TRANS/WP.29/GRSG/63
4 July 2003

World Forum for Harmonization of Vehicle Regulations (WP.29)

Working Party on General Safety Provisions (GRSG)

REPORT OF THE WORKING PARTY ON GENERAL SAFETY PROVISIONS (GRSG)
ON ITS EIGHTY-FOURTH SESSION

Annex 3, figure 7, amend to read:

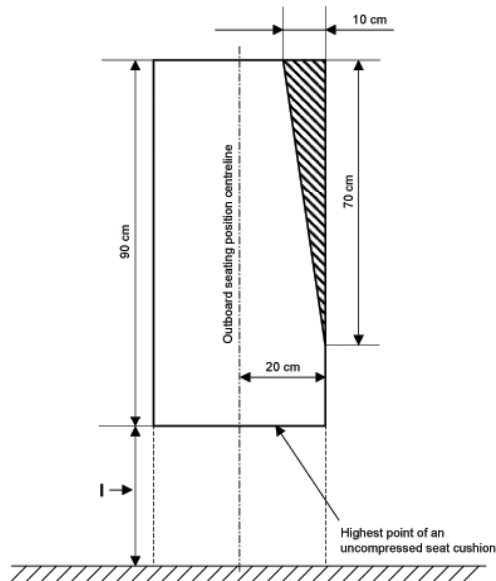
Paragraph 5.7.8.1.3.2., amend to read:

"5.7.8.1.3.2. Intrusion of a structural member provided that the intrusion is included within a triangle whose peak is situated 70 cm from the top and whose base is 10 cm in width and situated in the upper part of the space in question, adjacent to the side wall of the vehicle (see annex 3, figure 7)."

Paragraphs 7.6.3. and 7.6.4. (including its figures), amend to read:

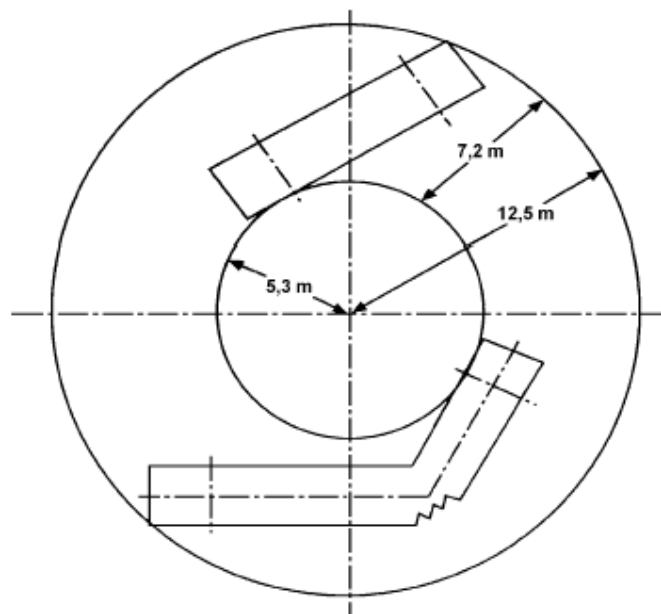
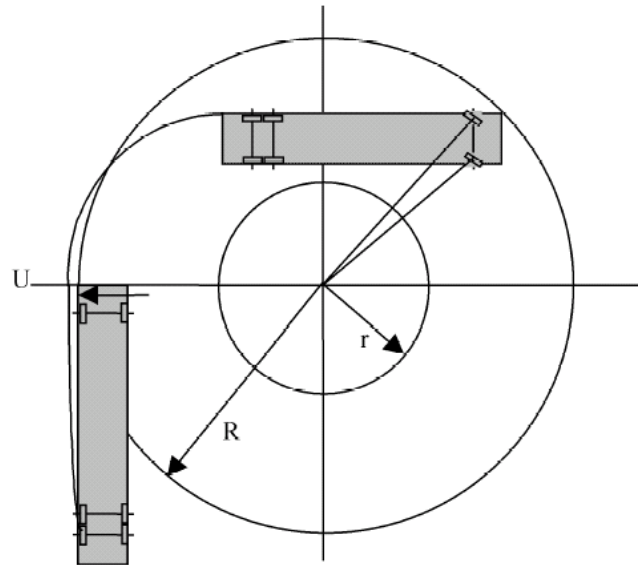
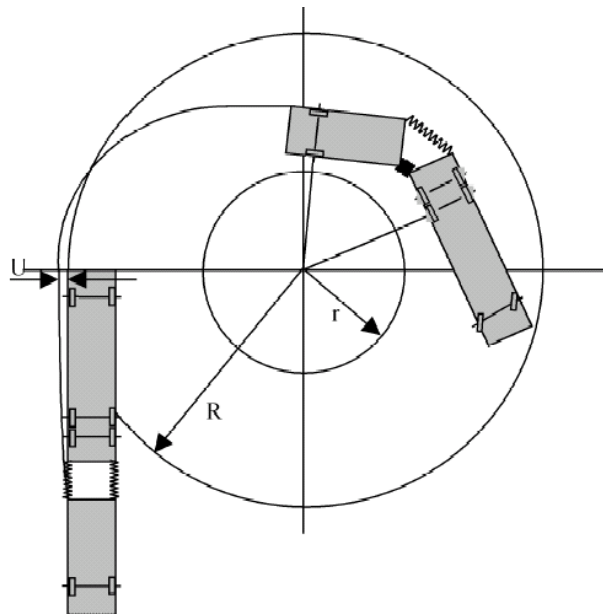
7.6.3.1. (A) With the vehicle stationary, a vertical plane tangential to the side of the vehicle and facing outwards from the circle shall be established by marking a line on the ground. In the case of an articulated vehicle, the two rigid portions shall be aligned with the plane. When the vehicle moves from a straight line approach into the circular area described in paragraph 7.6.1., no part of it shall move outside of that vertical plane by more than 0,60 m (see figures B and C).

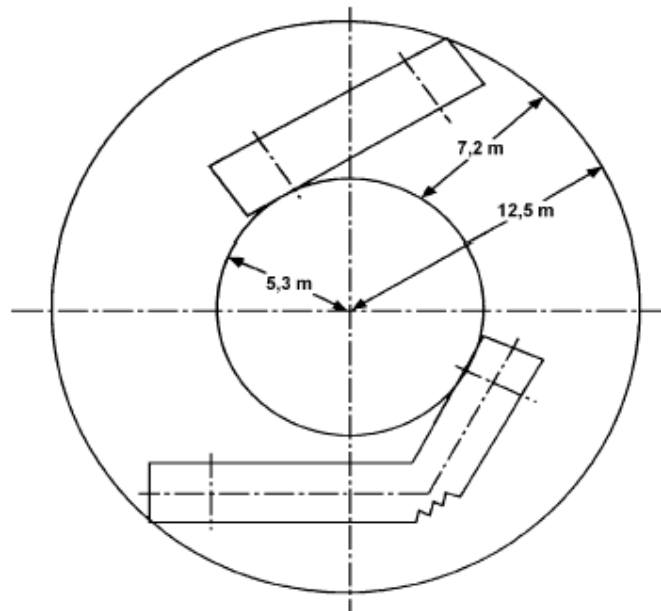
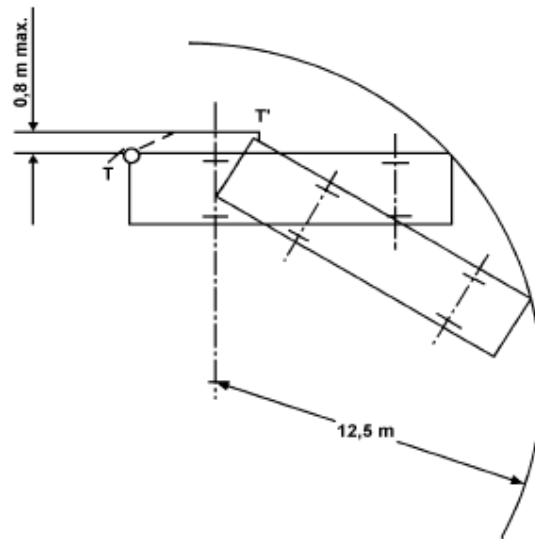
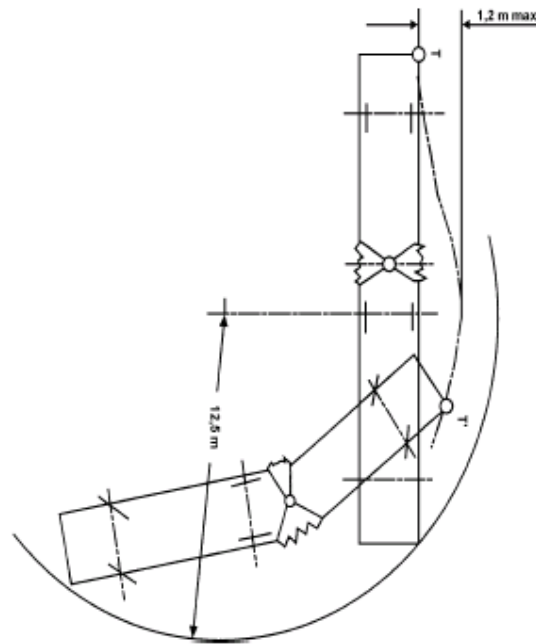
- 7.6.3.1. (B) When the vehicle is stationary and has its steered wheels so directed that if the vehicle moved, its outermost forward point would describe a circle of 12.50 m radius, a vertical plane tangential to the side of the vehicle which faces outwards from the circle must be established by marking a line on the ground. In the case of an articulated vehicle of category M2 or M3, the two rigid portions must be aligned with the plane.

When the vehicle moves forward on either side following the circle of 12.50 m radius, no part of it may move outside the vertical plane by more than 0.80 m (see Figure B) in the case of a rigid vehicle up to 12 m in length or by more than 1.20 m (see Figure C) in the case of a rigid vehicle of over 12 m in length or an articulated vehicle of category M2 or M3.
